SUBJECT: SEP TOPICS VI-2.D AND VI-3 EVALUATION REPORT
FOR MILLSTONE NUCLEAR POWER STATION, UNIT 1

SAFETY EVALUATION REPORT
ON
CONTAINMENT PRESSURE AND
HEAT REMOVAL CAPABILITY
SEP TOPIC VI-3
AND
MASS AND ENERGY RELEASE
FOR POSSIBLE PIPE BREAK
INSIDE CONTAINMENT,
SEP TOPIC VI-2.0
FOR THE
MILLSTONE 1 NUCLEAR POWER PLANT

DOCKET NO. 50-245

Figure 5. Drywell Pressure Response to a 0.75 ft² MSLB

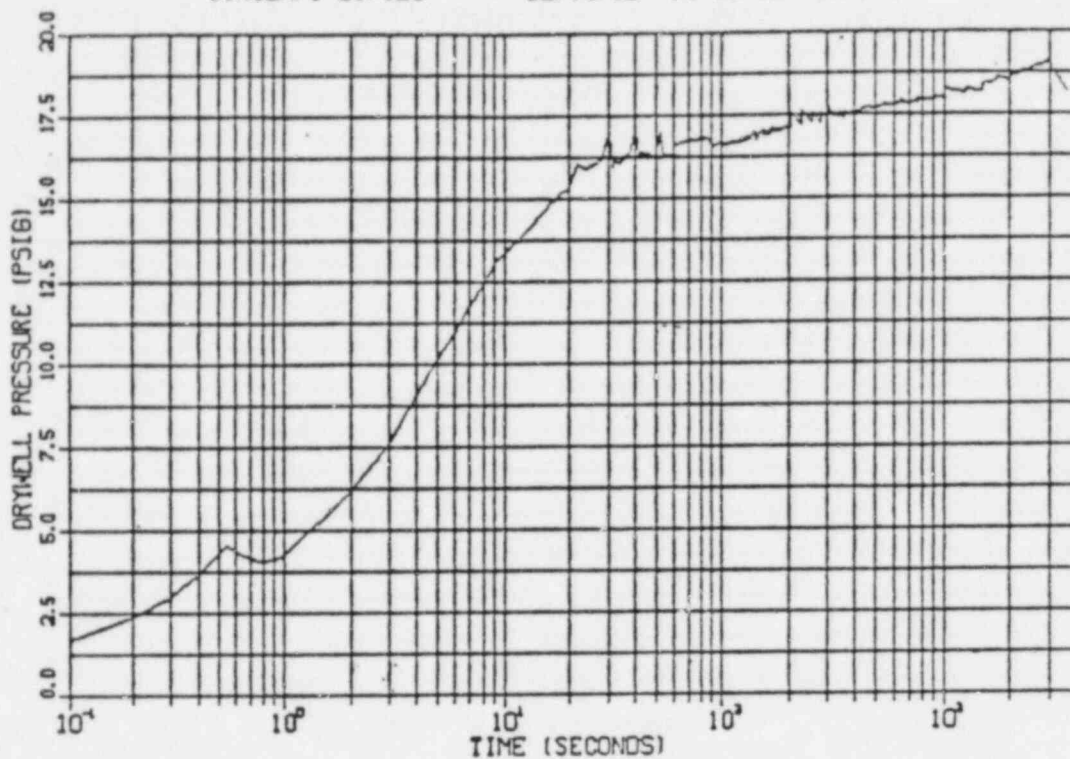
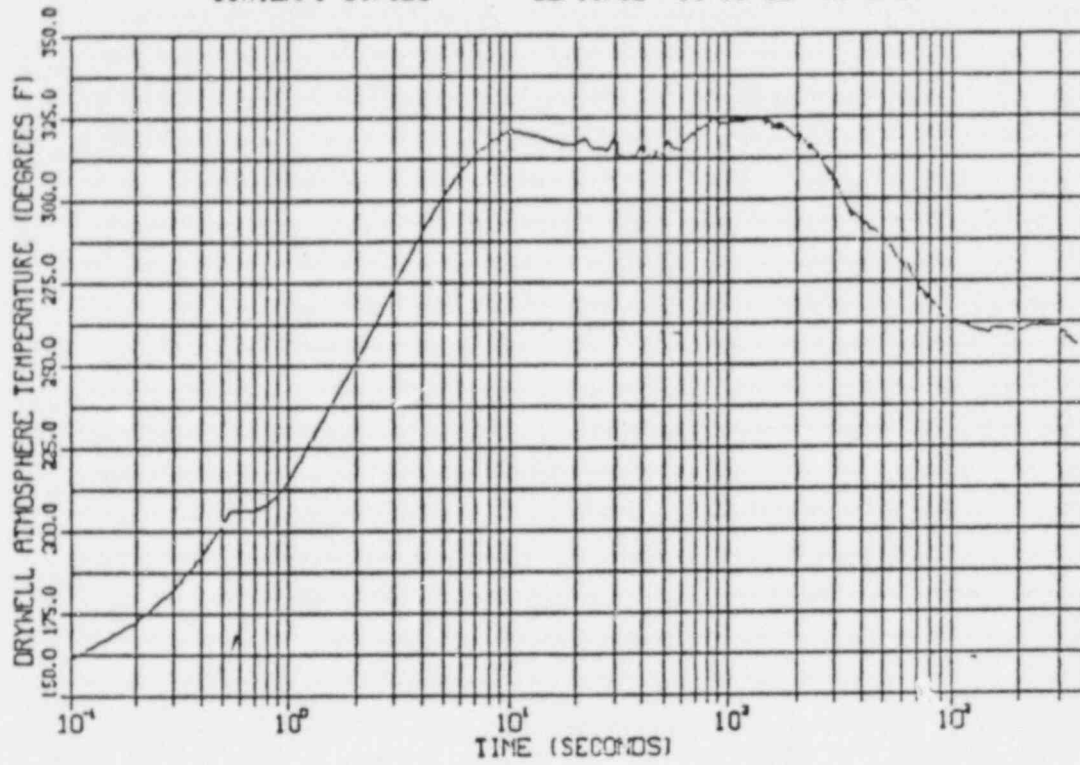
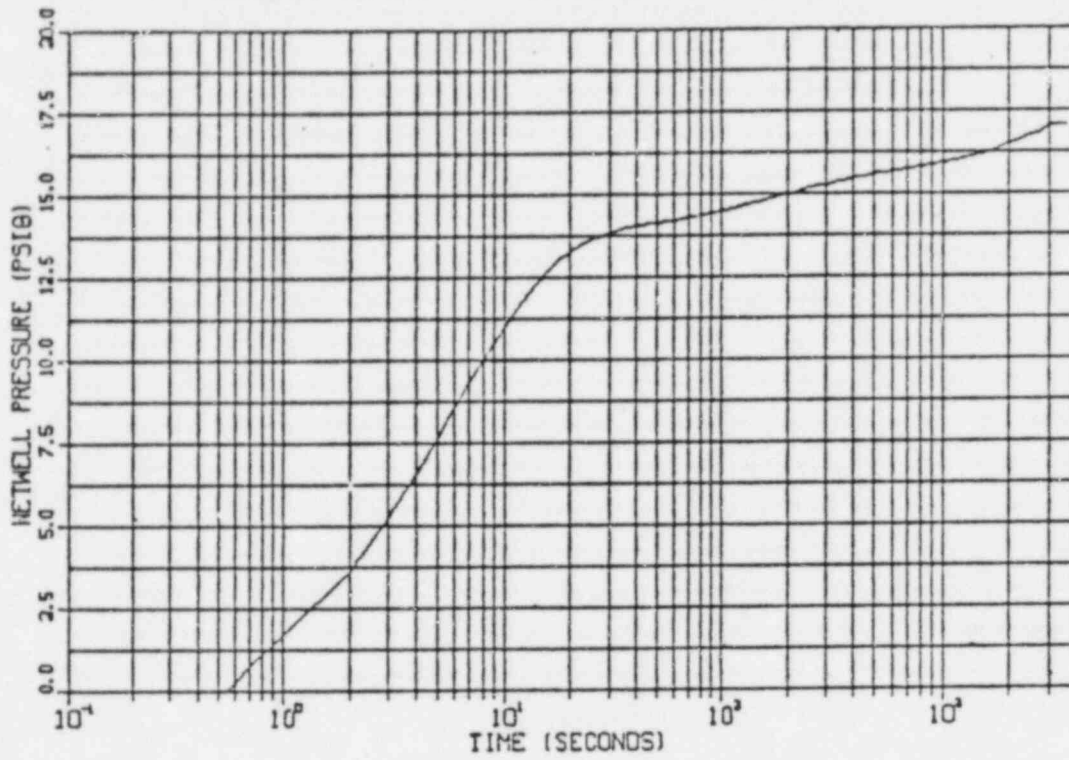
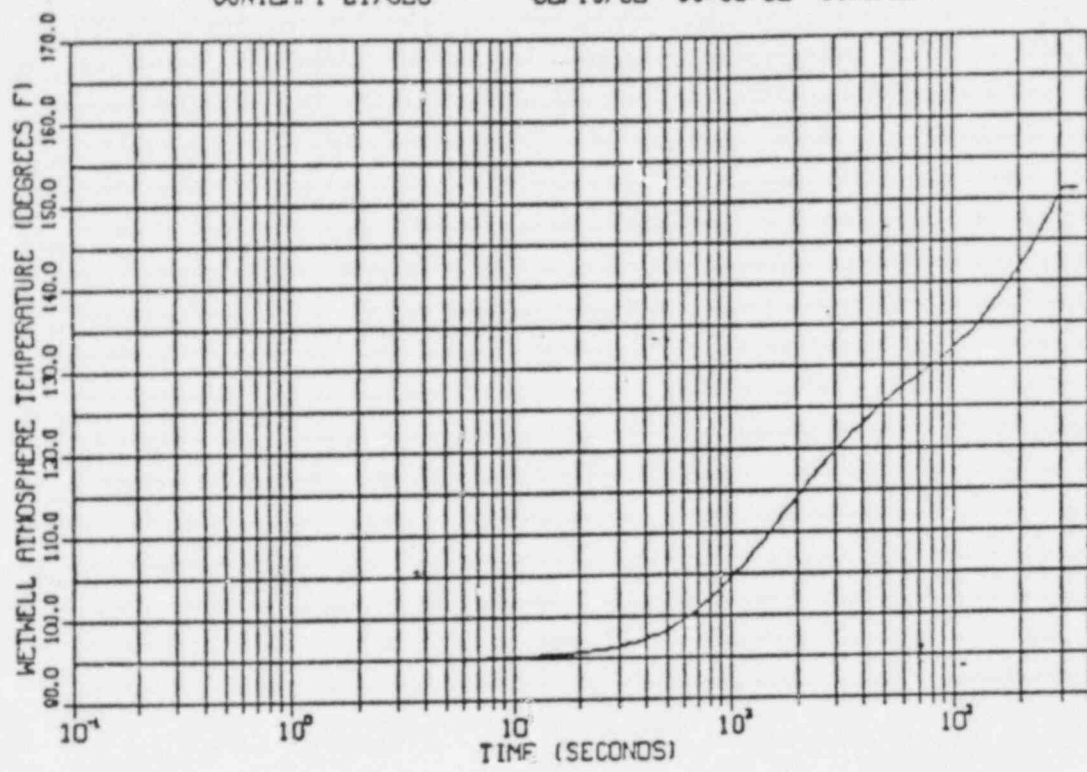
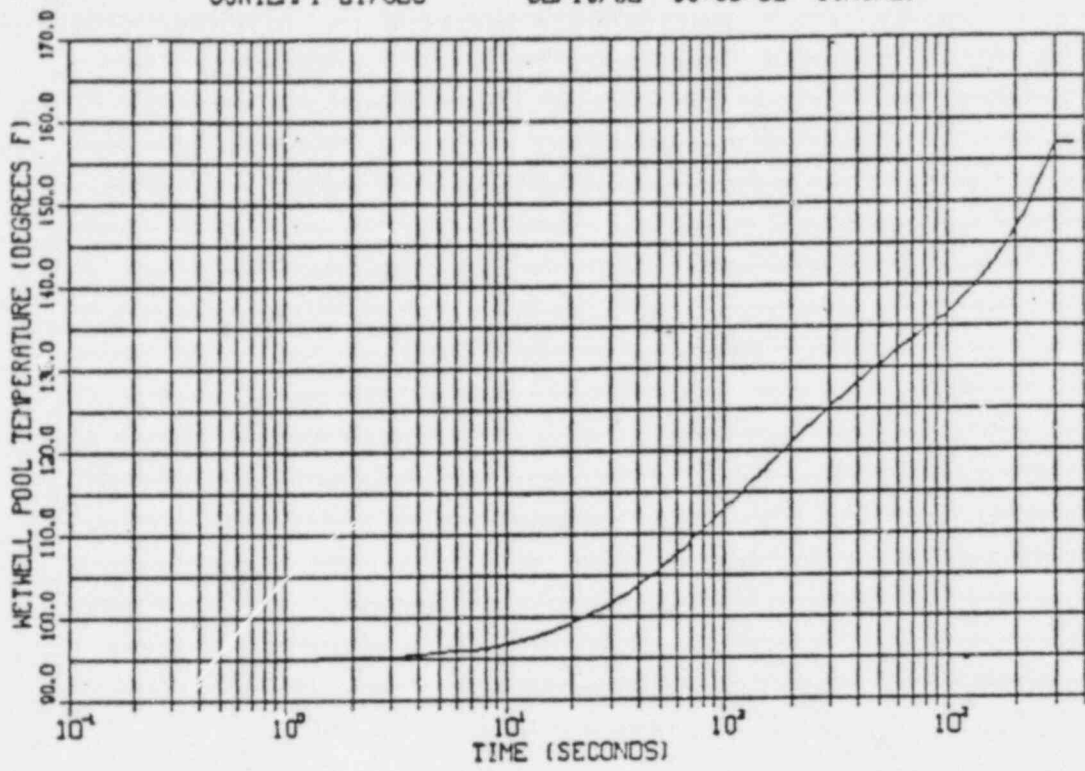
response to the $.75 \text{ ft}^2$ MSLB shows a maximum drywell pressure of 19.2 psig and a maximum temperature of 325°F . The wetwell maximum pressure and temperature are 17.1 psig and 157°F .

Figure 10. Drywell Pressure
Response to a 0.10 ft² MSLB

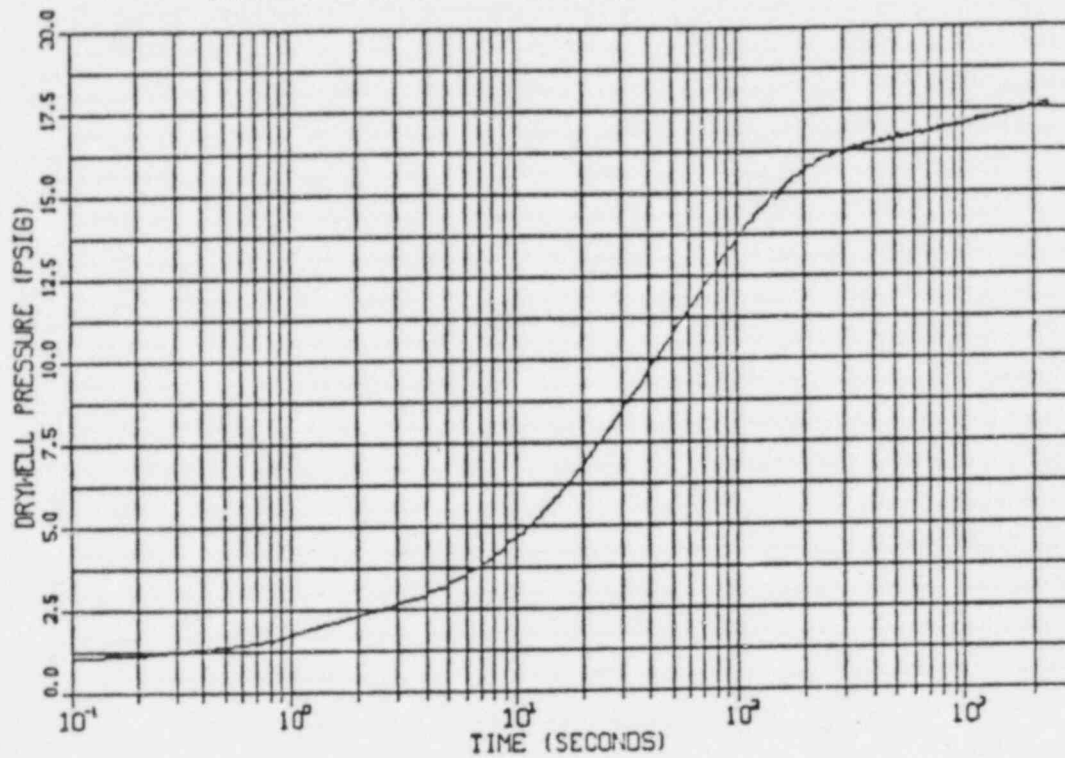
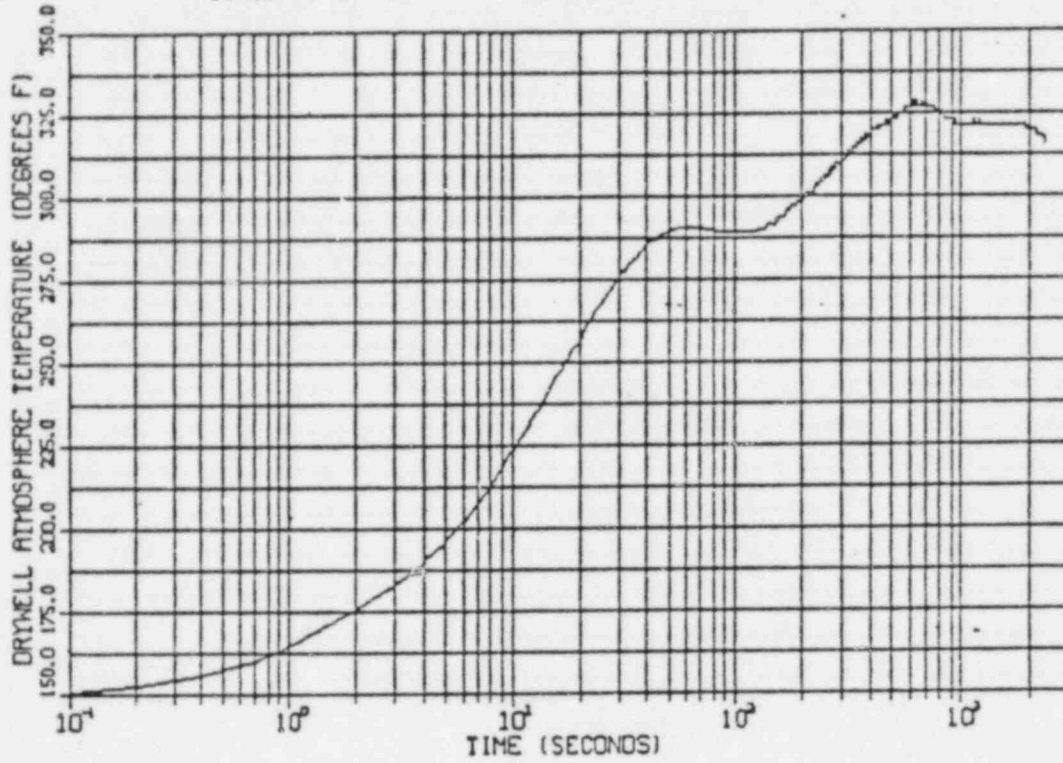
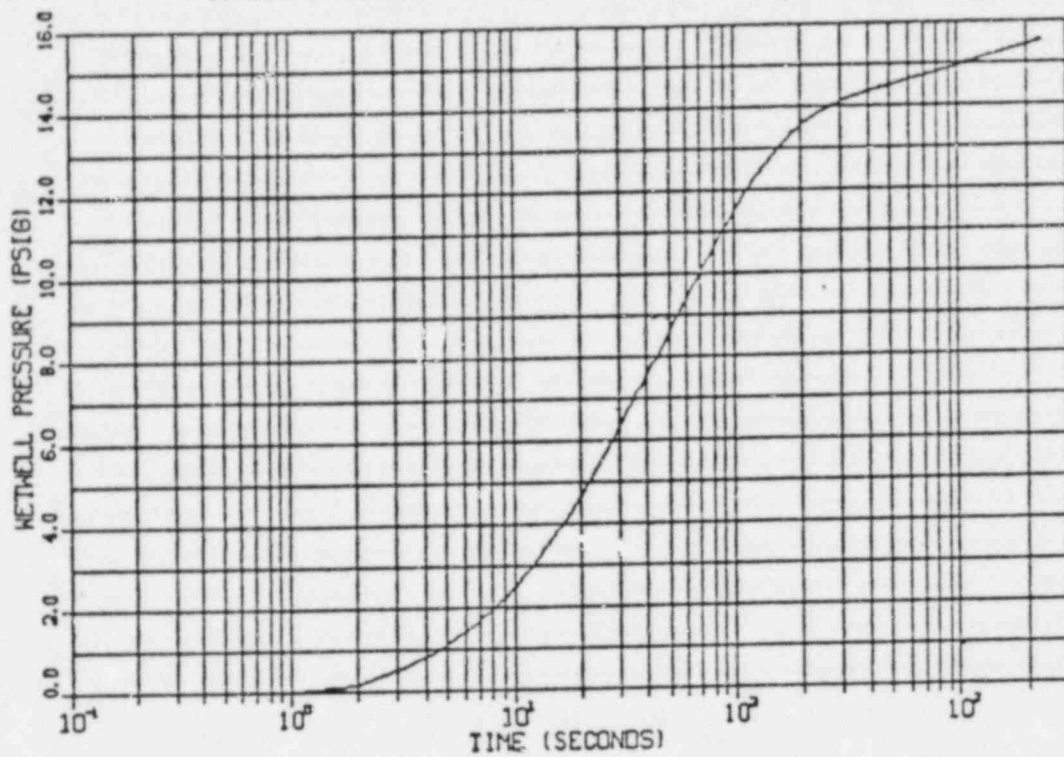
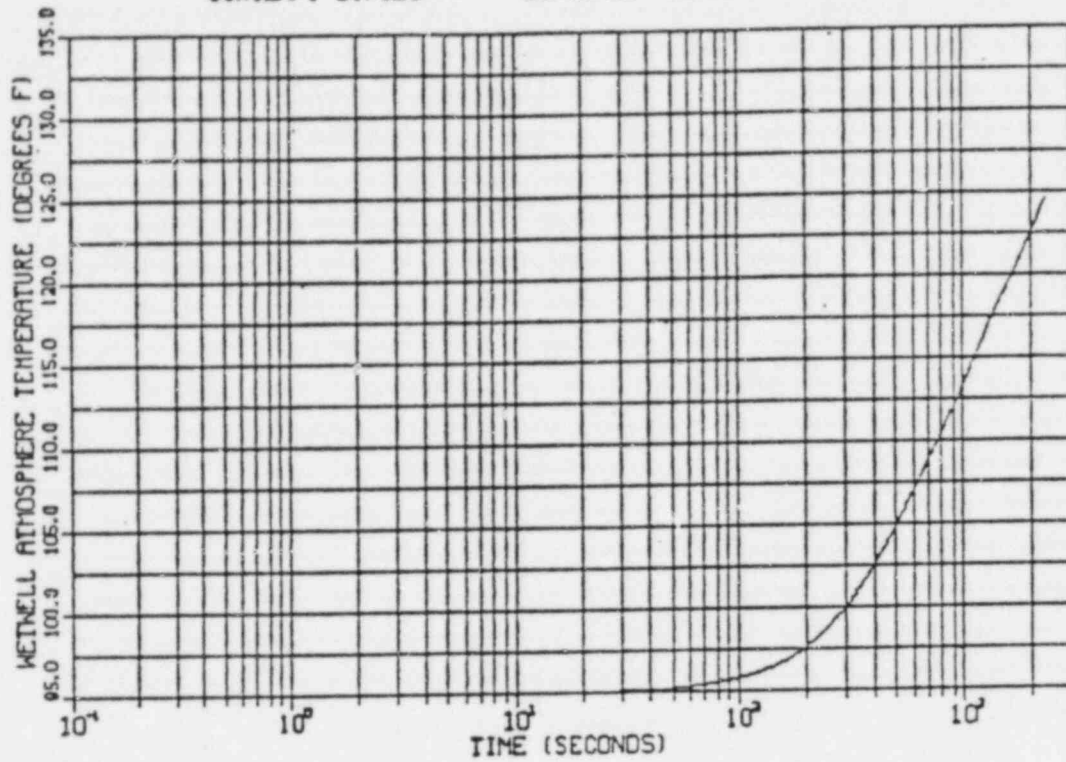
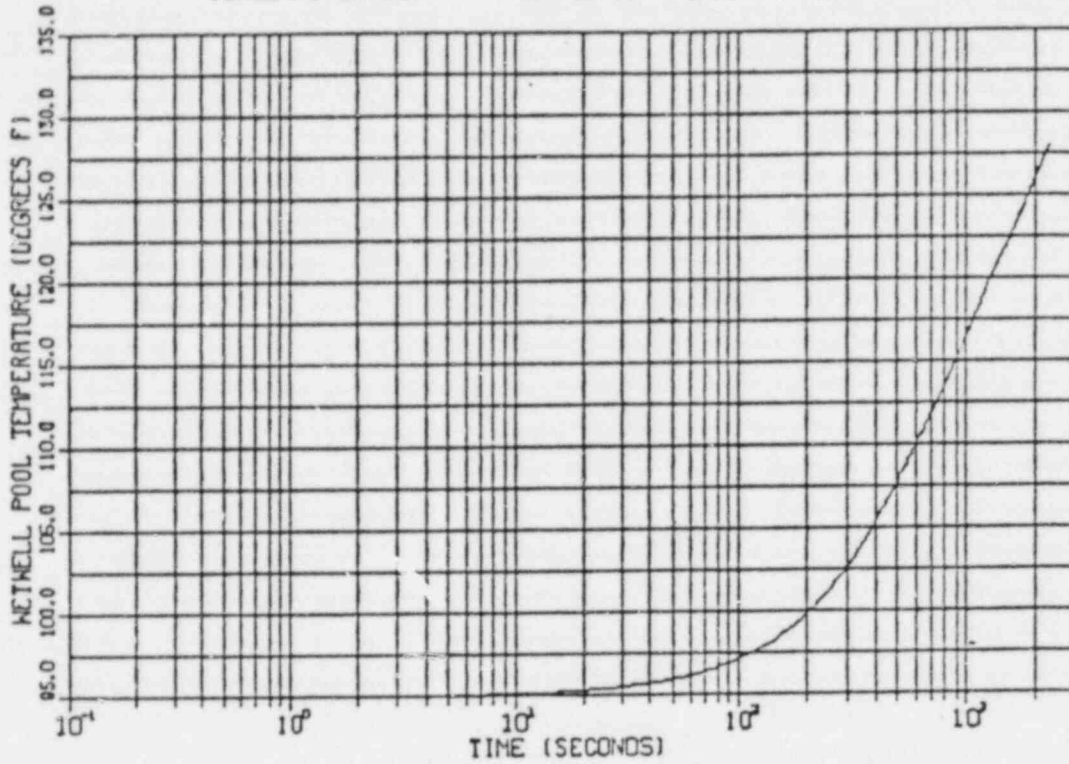
The Millstone 1 FSAR gives a containment design temperature of 281°F. The confirmatory containment analysis in response to a 0.1 ft² MSLB gives a calculated maximum drywell temperature of 328°F. The design temperature is exceeded. However, based on the results of SEP Topic III-7.B, "Design Codes, Design Criteria, Load Combinations, and Reactor Cavity Design Criteria" it was demonstrated that the containment could withstand the effect temperatures of 330°F without structural degradation.

The calculated containment response to the 0.1 ft^2 MSLB shows a maximum drywell pressure of 17.6 psig and maximum temperature of 328°F . The wetwell maximum pressure and temperature are 15.5 psig and 125°F .
